SUBJECT: Explanation of Significant Differences (ESD)
Operable Unit 2 (OU 2)
Broderick Wood Products Superfund Site

Explanation of Significant Differences
for the
Ground-Water Remedy

**Appendix A
Comments Received
on the Proposed
Explanation of Significant Differences**

Responsiveness Summary to Comments Received on the Proposed Explanation of Significant Differences

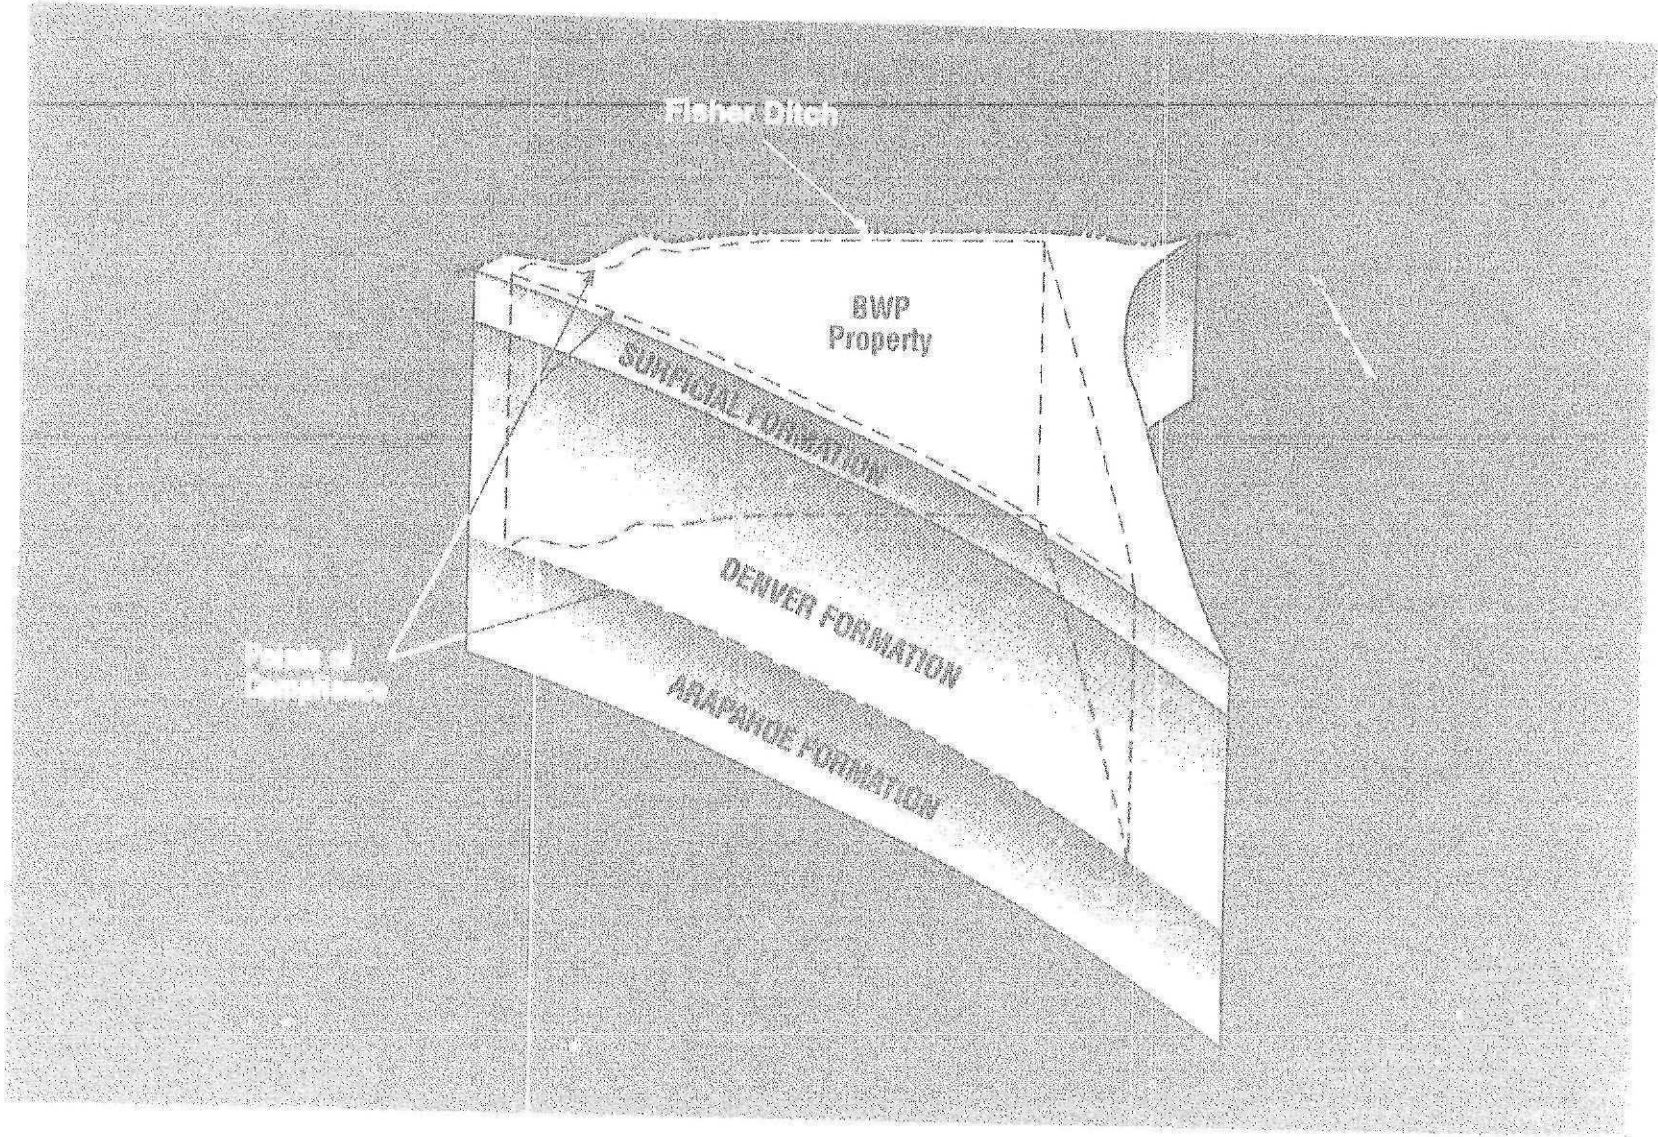
As stated in the text, Figure 1 depicts the model domain and contaminant plume. However, the figure does not show the model domain or boundaries, instead it is left to the reader to infer where model boundaries are located. The figure does not show monitoring well BFI-12, which should be in the middle of the plume off-site. Has BFI-12 been abandoned or mistakenly omitted from the figure? BFI-12 has a long history of water quality measurements and omission of the water quality data may affect the average concentration of PCP in the off-site ground water.

Figure 1 does not clearly describe what contaminant(s) are contained in the off-site plume. Is the extent of the plume based on total contaminants or on PCP? A clearer description of the plume's composition is necessary. It is assumed that the contaminant plume is for PCP only.

The measured concentrations of contaminants presented in a table on Figure 1 exclude concentrations from BFI-12, which will affect the average concentration. As previously stated, it is not clear what compounds are represented in the table. The table also shows concentrations of contaminants for GP-1, GP-2, GP-9, and GP-12 to be 50 ppb, and the table does not state how these measurements were obtained. One can only speculate that measurement of groundwater concentrations from geoprobes were taken using an on-site instrument that is not capable of precise measurements. The measurements used to determine the average concentrations of off-site ground water are suspect and are not be representative of actual concentrations.

BN is of the strong opinion that the construction of Figure 1 is highly subjective and is misleading. The averaging process used by CH₂M-Hill is biased and not technically justifiable. If the analysis for PCP in well BFI-9 is deleted from the average, as is suggested by CH₂M-Hill, and zero or 1/2 of the detection limit is used instead of the detection limit for the non-detects (a technically justifiable approach), then the average PCP concentration is 12 to 25 ppb not the 528 ppb stated in the table on Figure 1.

Figure 1—As stated in the text, Figure 1 depicts the model domain and contaminant plume. However, the figure does not show the model domain or boundaries, instead it is left to the reader to infer where model boundaries are located. The figure does not show monitoring well BFI-12, which should be in the middle of the plume off-site. Has BFI-12 been abandoned or mistakenly omitted from the figure? BFI-12 has a long history of water quality measurements and omission of the water quality data may affect the average concentration of PCP in the off-site ground water.

Figure 1 does not clearly describe what contaminant(s) are contained in the off-site plume. Is the extent of the plume based on total contaminants or on PCP? A clearer description of the plume's composition is necessary. It is assumed that the contaminant plume is for PCP only.

The measured concentrations of contaminants presented in a table on Figure 1 exclude concentrations from BFI-12, which will affect the average concentration. As previously stated, it is not clear what compounds are represented in the table. The table also shows concentrations of contaminants for GP-1, GP-2, GP-9, and GP-12 to be 50 ppb, and the table does not state how these measurements were obtained. One can only speculate that measurement of ground-water concentrations from geoprobes were taken using an on-site instrument that is not capable of precise measurements. The measurements used to determine the average concentrations of off-site ground water are suspect and are not representative of actual concentrations.

BN is of the strong opinion that the construction of Figure 1 is highly subjective and is misleading. The averaging process used by CH2M HILL is biased and not technically justifiable. If the analysis for PCP in well BFI-9 is deleted from the average, as is suggested by CH2M HILL, and zero or 1/2 of the detection limit is used instead of the detection limit for the non-detects (a technically justifiable approach), then the average PCP concentration is 12 to 25 ppb not the 528 ppb stated in the table on Figure 1.

Figure 1 of the TM was modified to show the model domain boundary and location of monitoring well BFI-12.

The plume represented in Figure 1 is for PCP concentrations. The average concentration used in the analysis may be biased by concentrations from well BFI-9. EPA recognizes the bias but believes that it was not a problem because even with high concentrations, contaminant levels reached low values through bioattenuation within a reasonable time. The analysis was intended to be conservative and the outcome was the same whether BFI-9 results were used or not. Adding BFI-12 data will not change this conclusion; therefore, no change is required to the TM Attachment to the ESD.

Figure 2
Generalized Hydrologic System

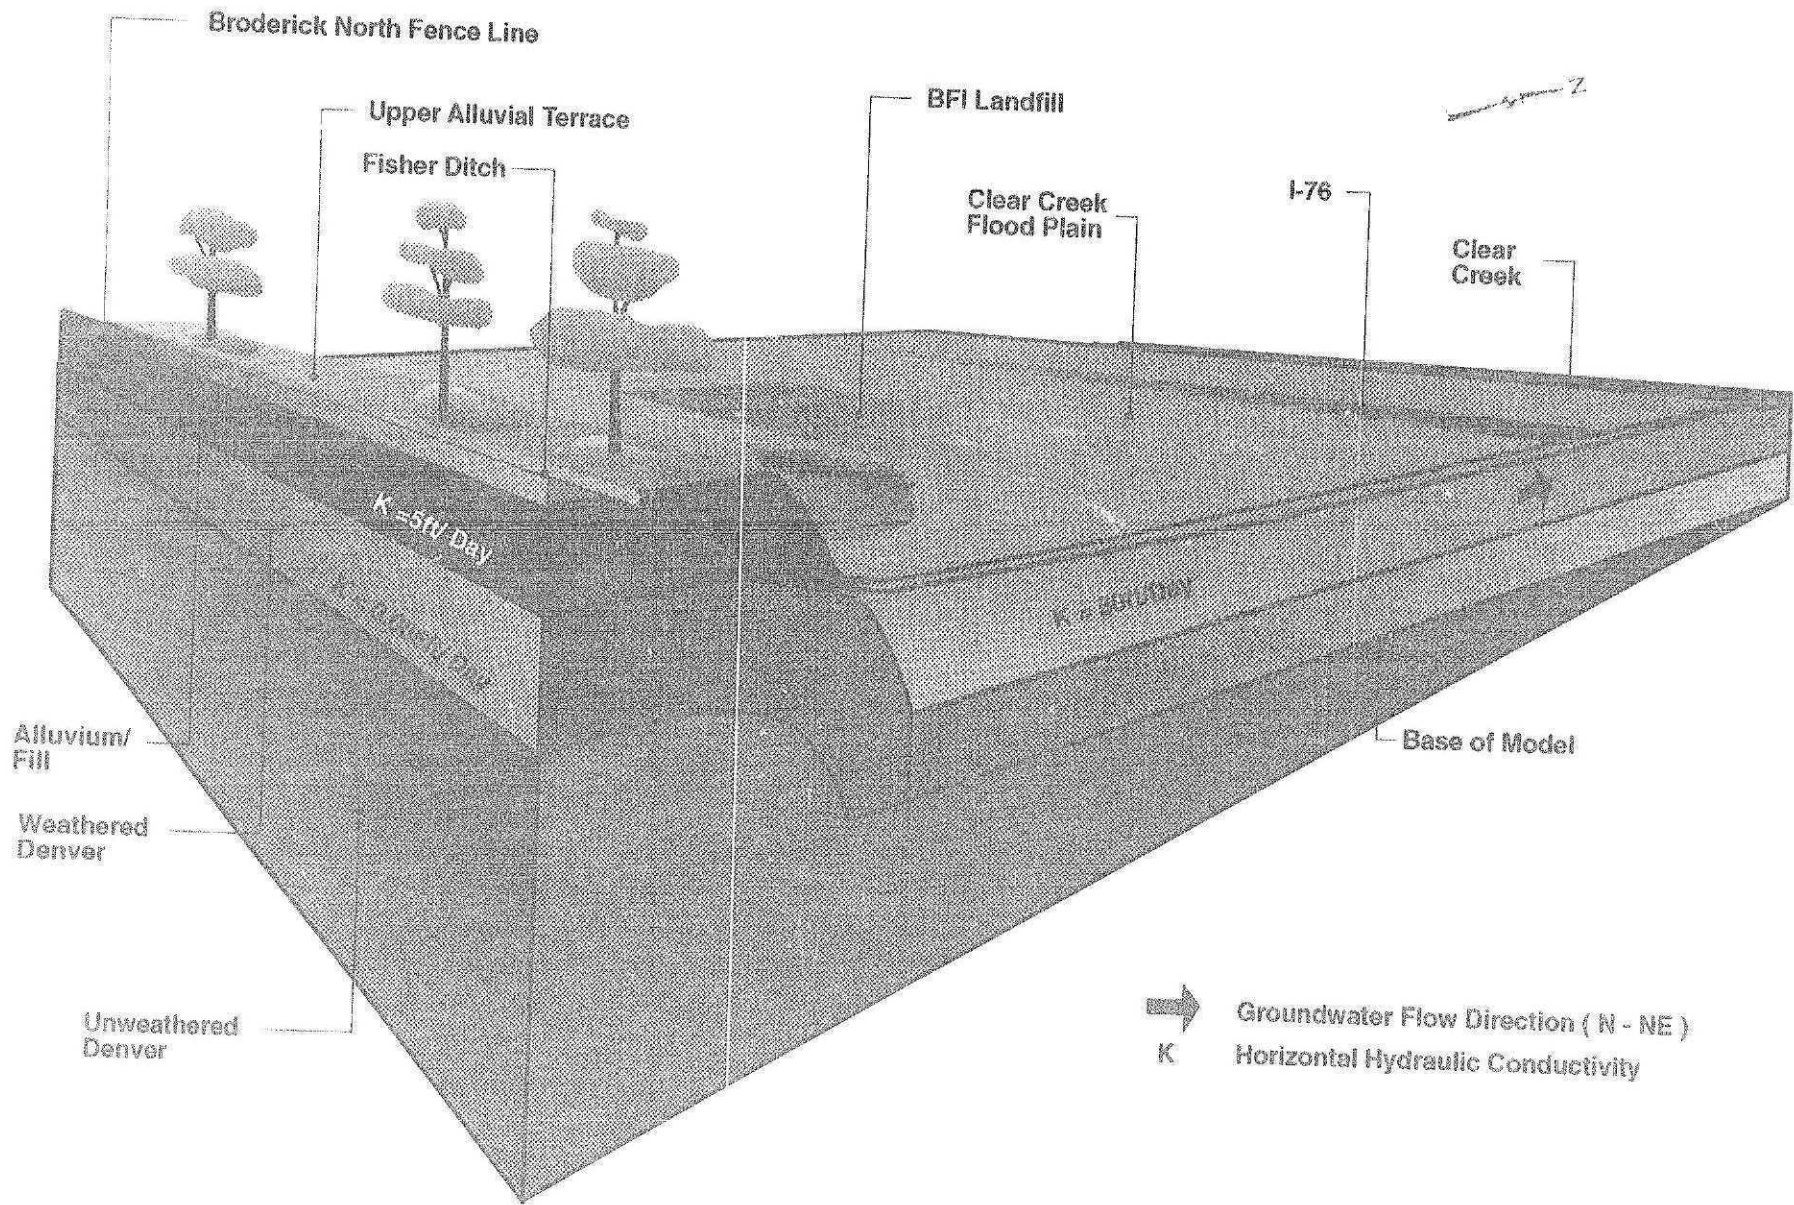
Figure 2 shows the hydraulic conductivity used for the alluvial terrace deposits, weathered Denver Formation, and flood plain deposits. The hydraulic conductivity for the alluvial terrace deposits is five feet/day, yet EPA's contractor claims that calculations during recent additional studies indicate that the hydraulic conductivity is much lower than originally estimated. BN's consultants estimated an average hydraulic conductivity for the alluvium to be seven feet/day. BN's consultant's estimate was based on information from Phase III investigations and the estimated hydraulic conductivity was used in a one-dimensional modeling effort to estimate cleanup concentrations for the shallow ground water. Furthermore, ReTeC used a similar value

Figure 2—Figure 2 shows the hydraulic conductivity used for the alluvial terrace deposits, weathered Denver Formation, and flood plain deposits. The hydraulic conductivity for the alluvial terrace deposits is five feet/day, yet EPA's contractor claims that calculations during recent additional studies indicate that the hydraulic

**BRODERICK OFFSITE
GROUNDWATER MODEL
PREDICTED HEAD MAP
FIGURE 7**

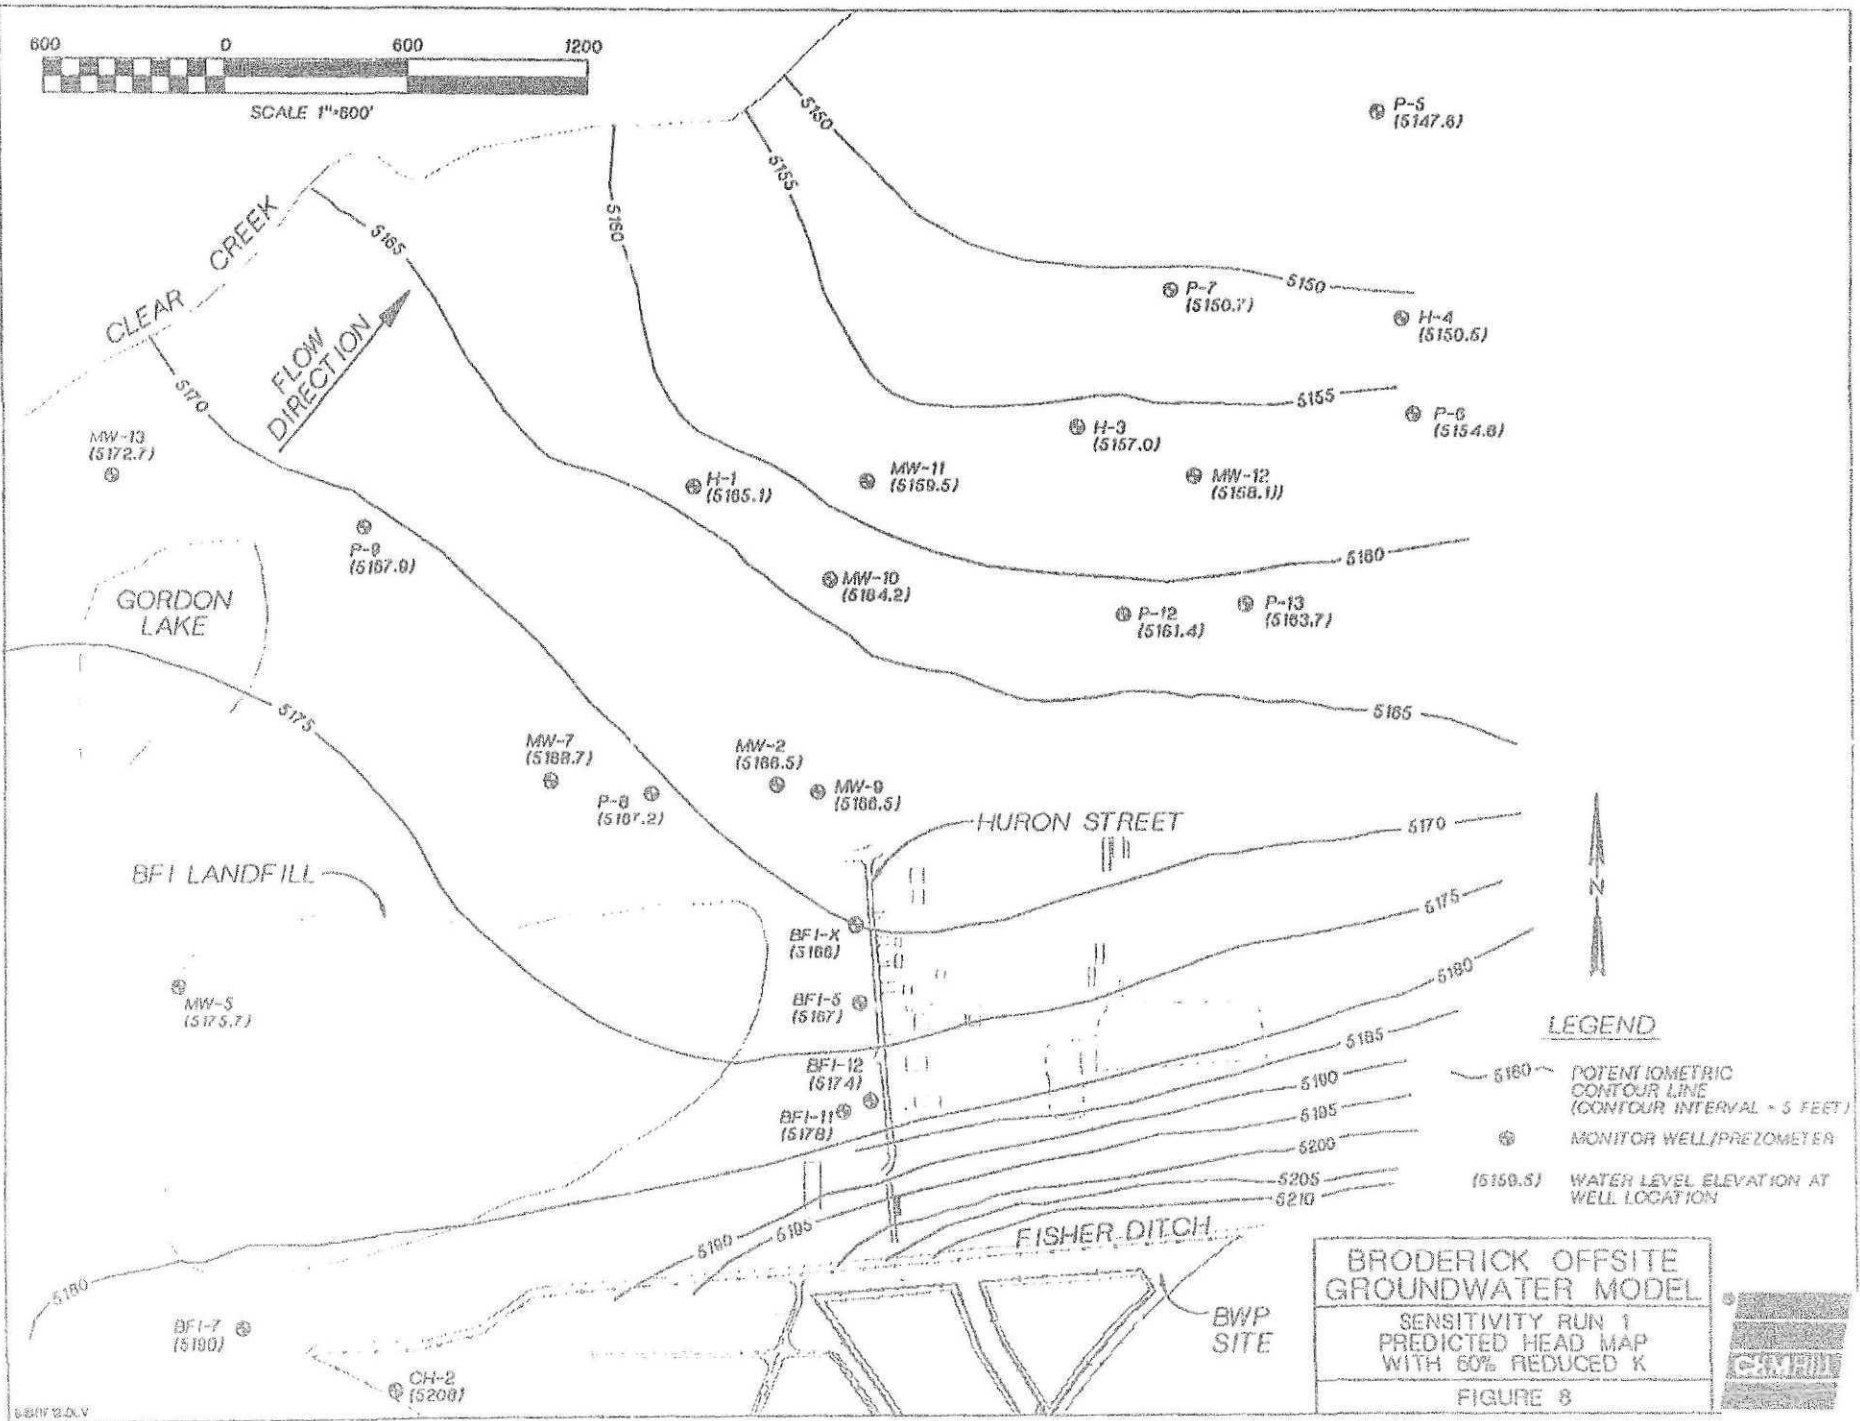
Residuals are as great as 12 feet in the southwestern portion of the model near BFI-7 and CH-2. Furthermore, the predicted potentiometric head map (Figure 7) does not fit well with the

As previously stated, the predicted head map does not accurately match with measured data. The probable reason for this is that the constant flux boundary assigned to Fisher Ditch is not correctly assigned in the model. The TM states that Fisher Ditch contributes water to the shallow ground water. Fisher Ditch is known to flow from west to east, but in viewing the potentiometric contour lines along Fisher Ditch on Figure 7 and assuming that water from Fisher Ditch reaches the water table uniformly, the potentiometric lines indicate that flow in the ditch is in the opposite direction, from east to west.

Residuals are as great as 12 feet in the southwestern portion of the model near BFI-7 and CH-2. Furthermore, the predicted potentiometric head map (Figure 7) does not fit well with the measured water levels. The gradient immediately north

Figure 7—As previously stated, the predicted head map does not accurately match with measured data. The probable reason for this is that the constant flux boundary assigned to Fisher Ditch is not correctly assigned in the model. The TM states that Fisher Ditch contributes water to the shallow ground water. Fisher Ditch is known to flow from west to east, but in viewing the potentiometric contour lines along Fisher Ditch on Figure 7 and assuming that water from Fisher Ditch reaches the water table uniformly, the potentiometric lines indicate that flow in the ditch is in the opposite direction, from east to west.

The comment states that a (modeled) gradient immediately north of the site boundary is 90 degrees different from the measured gradient. Figure 6 of the TM shows the observed ground-water potentiometric surface at and north of the site. Figure 7 of the TM shows the predicted potentiometric surface. Close comparison of these figures demonstrates very good agreement between the observed and
